Preliminary Plat

**ITEM #4 - PRELIMINARY PLAT
HAUCK'S VIEW SUBDIVISION #2**

KPB File No.	2024-010
Plat Committee Meeting:	February 12, 2024
Applicant / Owner:	Richard Hauck of Kasilof
Surveyor:	Jerry Johnson / Johnson Surveying
General Location:	Cohoe Loop Road in Cohoe area

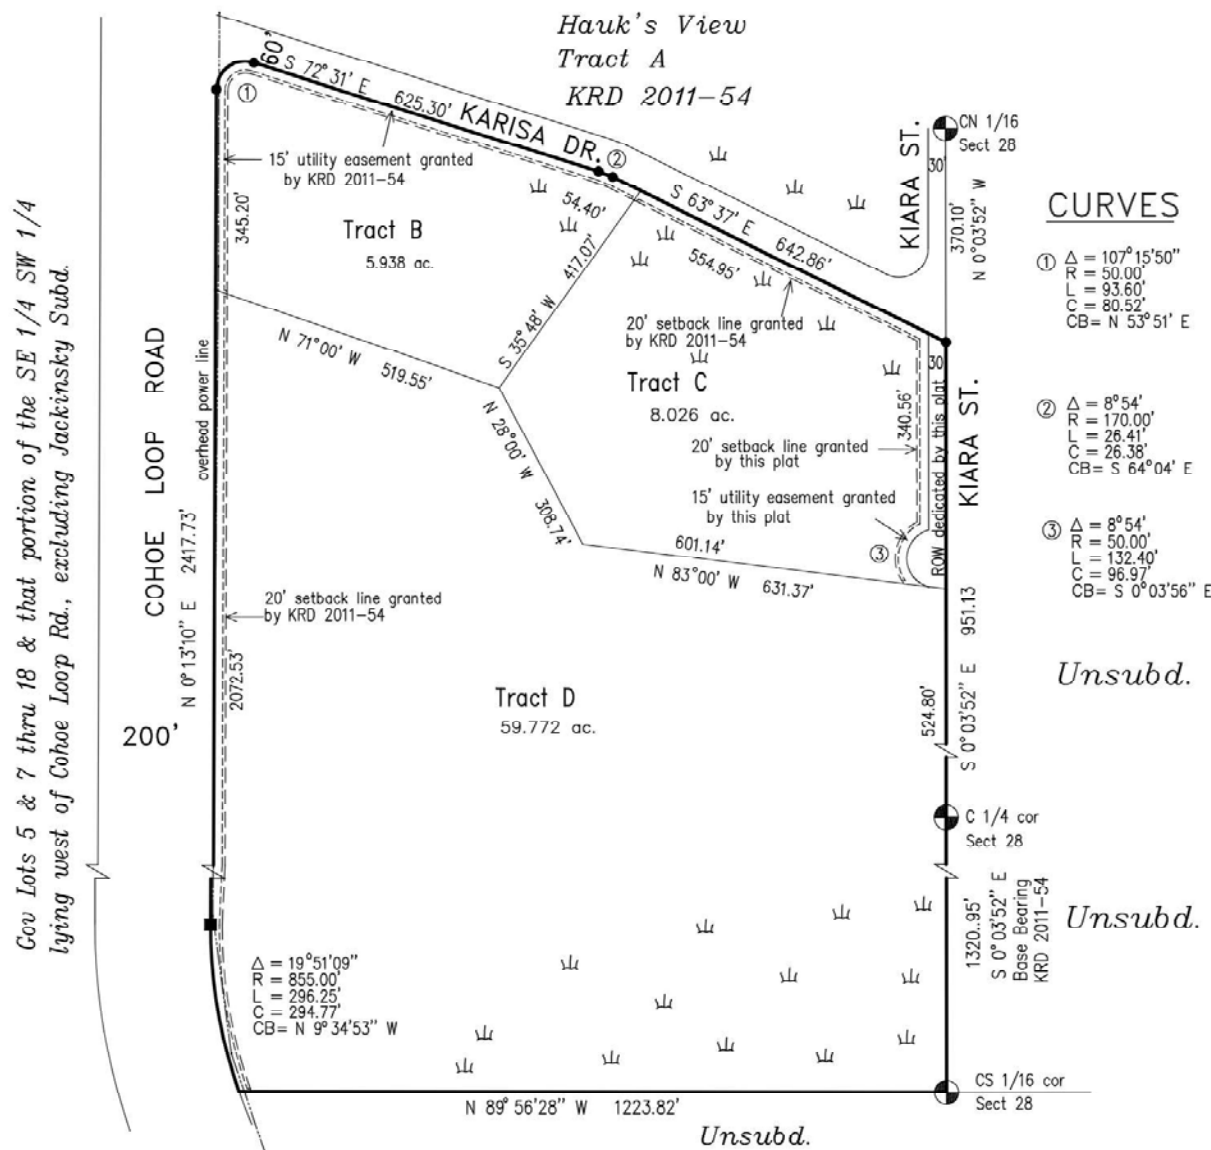
The plat is proposing a dedication of a half cul-de-sac on the east side running along Tract C to be named Kiara St. the surveyor may consider extending the bulb of the cul-de-sac into Tract D to make future development and extension of Kiara St easier as only Tract D would need to be involved. To bust the bulb of the road for extending, any tract adjacent would most likely be involved in the platting and extension of the road.

In the deed filed at serial 2003-0003654-0, there is mention of the property being subject to a 30-foot wide public access easement, the south 30 feet of the described real property in the deed. This easement needs to be shown on the drawing.

There are some wetlands on the plat shown. Upon looking at the KWF wetlands assessment map from KPB data it appears the wetlands cover a little more area than shown. **Staff recommends:** the surveyor review the KWF wetland assessment site and adjust the limits of the wetlands on the plat to accommodate as needed. The

The plat notes indicate a 15' utility easement which is also shown on the drawing as being dedicated by KN 2011-54. Hauck's View KN 2011-54 dedicated only a 10' utility easement in the notes given. Per KPB 20.30.060(D), only a 10' utility easement is required. The surveyor can leave the easement at 15' or change it to 10' if so desired.

HEA has requested that the overhead powerline on the west side of the subdivision be labeled of a plat note be added stating "The existing overhead powerline is the centerline of a 30-foot-wide electrical easement, including guys and anchors, granted this plat." Plat note #3 carried forward from the previous plat states that the easement size is 20'. **Staff recommends:** Plat note #3 be amended to accommodate HEAs request to make easement 30'.

Revise owner name to Richard T Hauck as shown on certificate to plat

Add 2024-010 to Kenai Peninsula Borough File

Add Box to the address PO ____ 1096

Label Karisa Drive

To the north, filing label needs corrected

- Roads must meet the design and construction standards established by the borough in order to be considered for certification and inclusion in the road maintenance program (KPB 14.06).
- The borough will not enforce private covenants, easements, or deed restrictions per KPB 20.60.170. Remove the statement "These are KPB imposed covenants" in plat note 4.
- Add reference to note 4 on the certificate to plat to the drawing.

Show measured and recorded date and source
